# Access Compliance Report

## Public Rights-of-Way

Intersection ID: 13618	Main Street: S_CALDWELL_ST	Cross Street: TEMPLETON_AV	Location: E
ADA ID: 8F8F34A52591	Ramp Type: Directional1	Initial Pass/Fail: Fail	Overall Compliance: No
Severity Score: 1.25			
Codes/Mitigation Info/Possible Solution		Field Measurements/Component Compliance

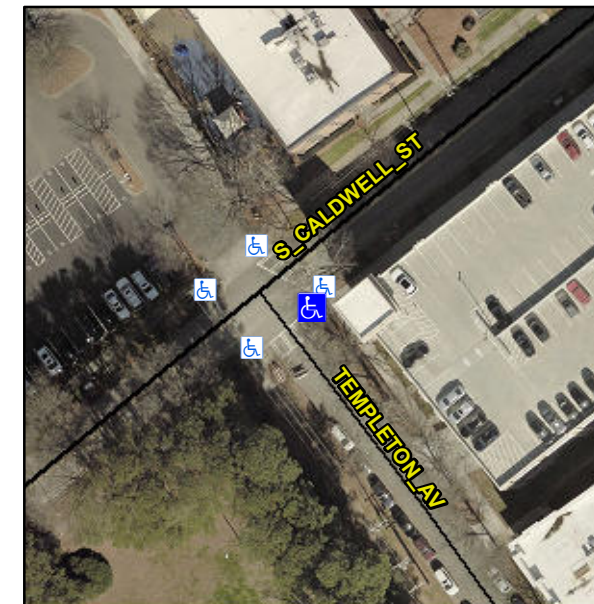
**Remove & Replace Entire Ramp.**

**R304.5.3**
